Response to the Reviewer's comments - review 1

Investigation into Instantaneous Centre of Rotation for Enhanced Design of Floating Offshore Wind Turbines.

Figure 1: ICR statistics for different one-at-a-time design variable perturbations for a spar FOWT. Original design values marked with black outline.

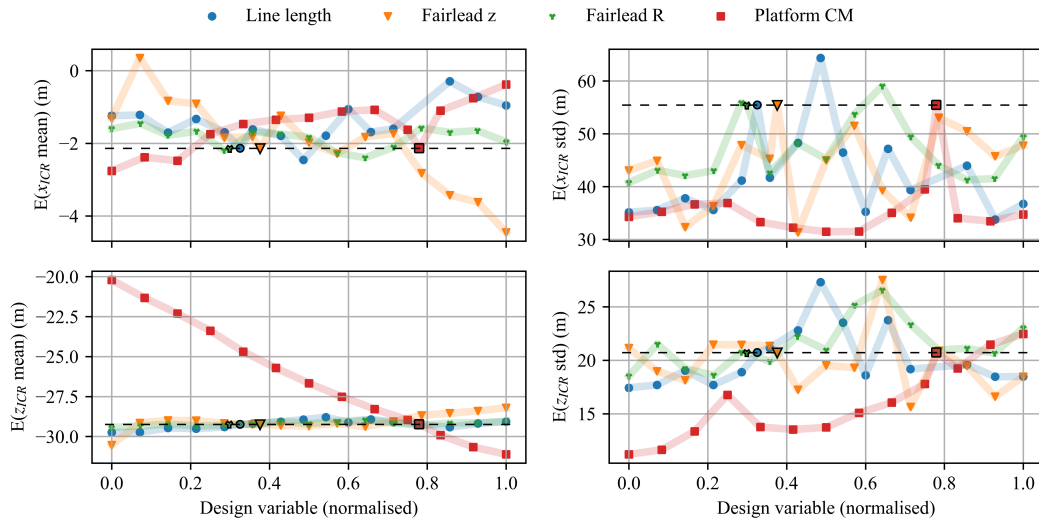
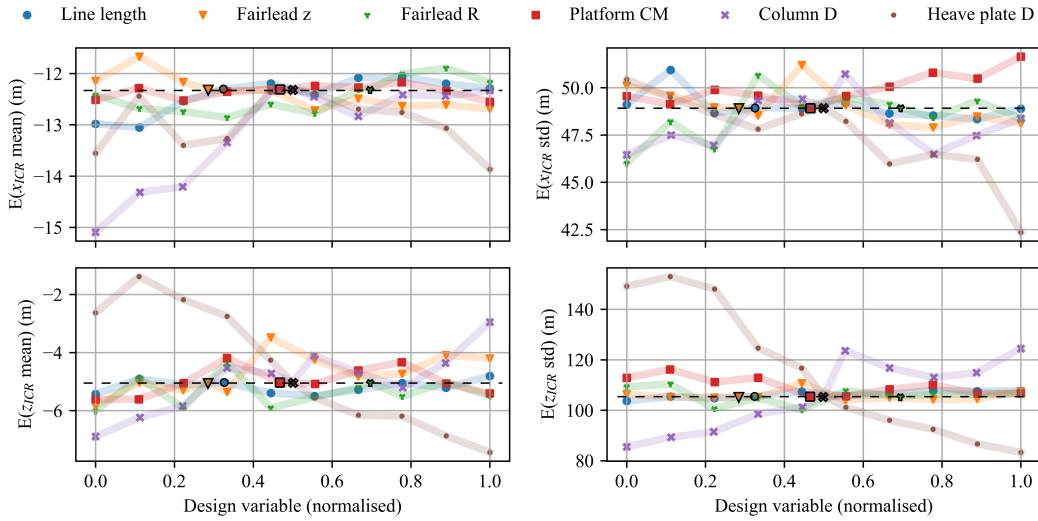
Comment 7 "Figure 17: Why do the original design values show different ICR values? Shouldn't all original design values share the same ICR value? The original design values should all represent the same original design configuration and thus have same result values".

Response 7 Thank you for noticing this, that is correct. The results were generated by systematic variations of the variables between the minimum and maximum values and the original design values were not always part of the design matrix; the markers corresponding to the original designs were mislocated.

Modification 7 We have now added the results of the original design and marked the correct original design values in Figures 19 and 20 (note that these are also updated in response to other comments).

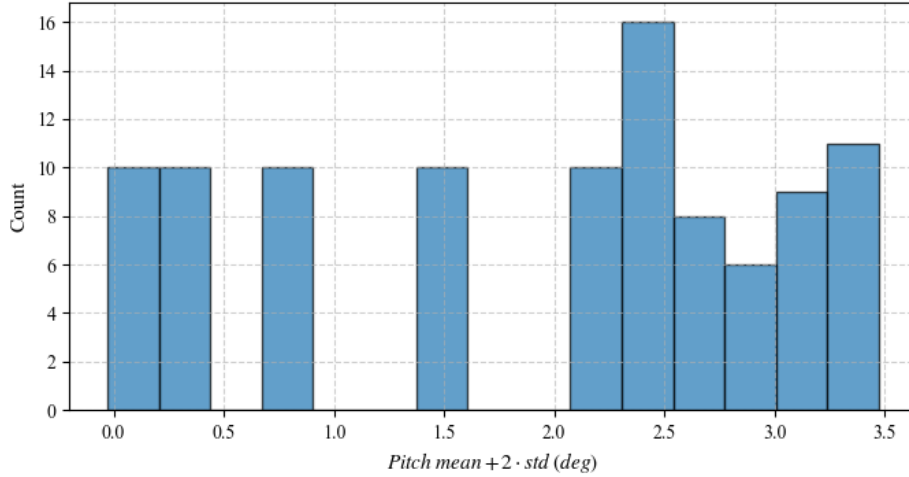
Comment 10 ”Table 13. (Offset column d, mean Re-vol. value 8.38): Offset column has a major impact on hydrostatic stiffness and restoring. Reducing the parameter by this extend is would probably result in insufficient floating stability thus large tilt during power production and even risk of capsizing/downflooding”.

Response 10 We double-checked the maximum pitch angle from the simulations of the different variants of the semisubmersible, as presented in the figure below. All designs had sufficient stability in all conditions considered (including that of maximum thrust).
